LEO V2.800.0000000.26.R.210421

Release Notes

Item	Description
Product model	Leo Platform Series 32/34/35; Economic Fisheye Camera
Version	V2.800.0000000.26.R.210421
Software package information	DH_IPC-HX3XXX-Leo_MultiLang_NP_Stream3_V2.800.0000000.26.R.210421.zip DH_IPC-HX3XXX-Leo_MultiLang_PN_Stream3_V2.800.0000000.26.R.210421.zip DH_IPC-HX5(4)(3)XXX-Leo_MultiLang_NP_Stream3_V2.800.0000000.26.R.210421.zip DH_IPC-HX5(4)(3)XXX-Leo_MultiLang_PN_Stream3_V2.800.0000000.26.R.210421.zip DH_IPC-HX5(4)(3)XXX-Leo_MultiLang_NP_Stream3-USA_V2.800.0000000.26.R.210421.zip DH_IPC-EX5XXX-Leo_MultiLang_NP_Stream3_V2.800.0000000.26.R.210421.zip DH_IPC-EX5XXX-Leo_MultiLang_PN_Stream3_V2.800.0000000.26.R.210421.zip DH_IPC-EX5XXX-Leo_MultiLang_NP_Stream3-USA_V2.800.0000000.26.R.210421.zip
OS requirement	None
Release date	April 26, 2021

1.4.1 Algorithm Optimization for Big-animal False Alarm Based on SMD Function

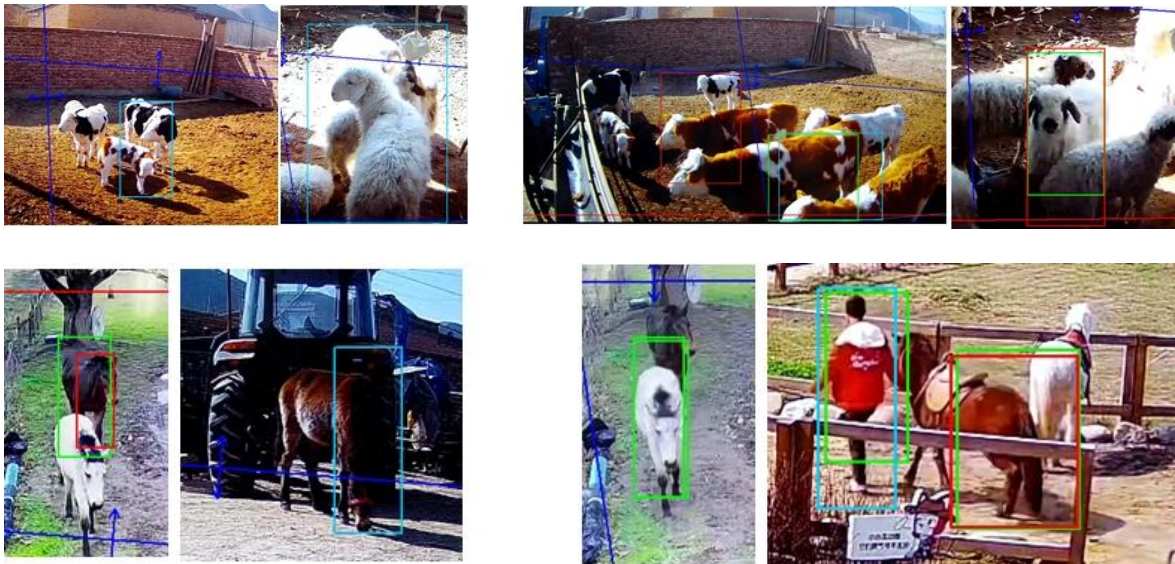
Through the optimization of the algorithm detection model, the SMD function is optimized for the released Series 3 products, and the detection optimization is mainly for the large animal (such as cattle, horse, and sheep). The main optimization points are as follows:

The current SMD function only detects people and vehicles. Version 2.0 optimizes the false alarm of small animals, such as cats and dogs in the family. Version 3.0 optimizes the algorithm for large outdoor animals and trains massive animal data. If an animal trips the rule line, SMD will filter out the alarm triggered by animals and only keep the alarm triggered by people and vehicles.

The following false alarm will be filtered out:

1.4.2 AI Coding

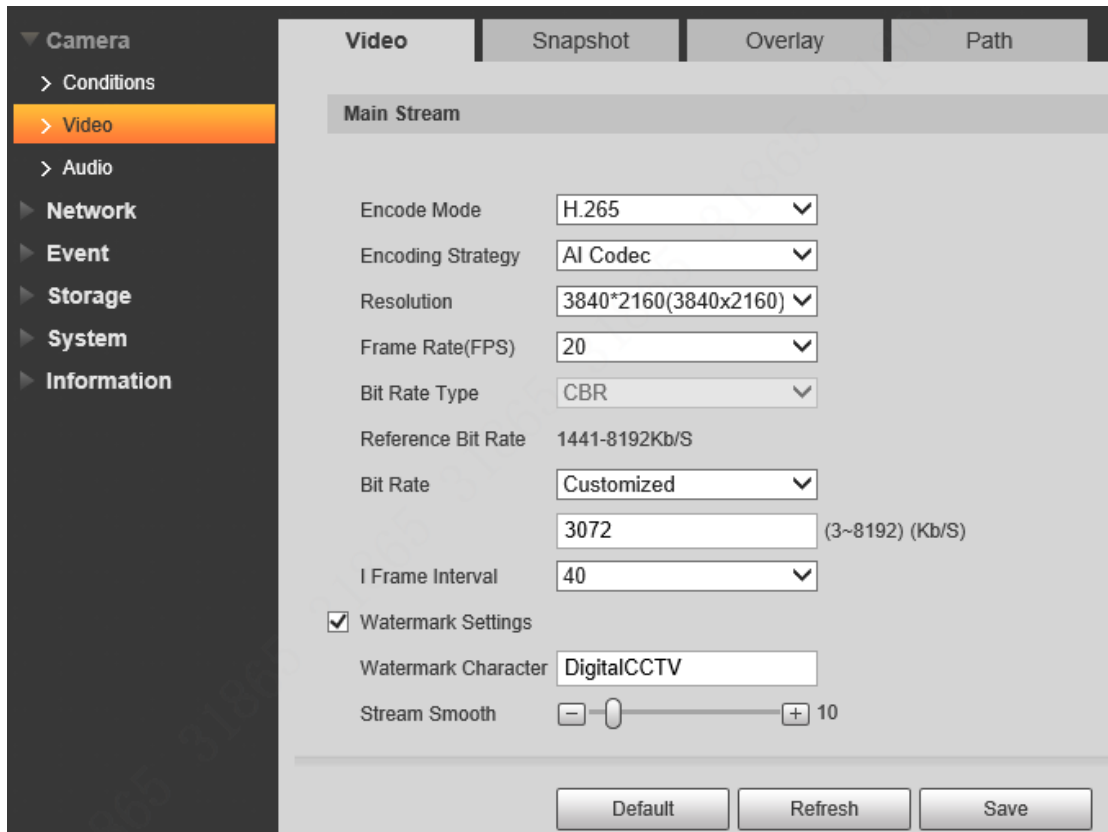
- AI codec mode is added to the main stream interface. You can select the encoding strategy as **General**, **Smart Codec**, and **AI Codec**.
- When selecting **AI Codec**, the bit rate type automatically switches to **CBR**, and the bit rate decreases by 25% compared to General mode.
- When selecting **AI Codec**, you can select frame rate as 1x or 2x under **I frame interval** list. It is 2x by default.
- The AI Codec mode is only added for devices with AI functions.
